# Dealer Service Technical Bulletin

NUMBER: 78-TM-1

**SUBJECT: IGNITION PAK REPLACEMENT**

**MODELS: ALL MOTORHOMES WITH SOL-AIRE FURNACE EXCEPT TWIN BED MODELS**

Figure 1

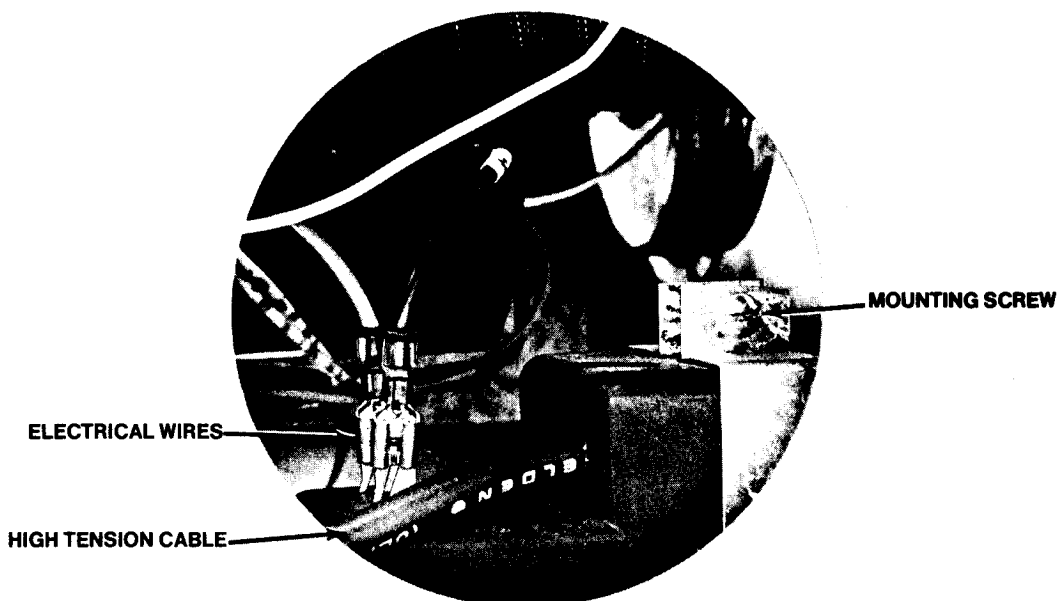
This bulletin is intended to provide information for simplifying the service procedure required to remove and replace the ignition pak. This will replace the procedure in Maintenance Manual X-7525, Page 24G-13.

1. Position ignition pak under mounting strap as shown in Figure 1. Tighten mounting screw.
2. Connect two electrical wires to terminals on ignition pak.
3. Connect high tension cable to ignition pak.
4. Install heat duct on side of furnace.
5. Install remaining trim panel on vehicles equipped with swivel chairs.
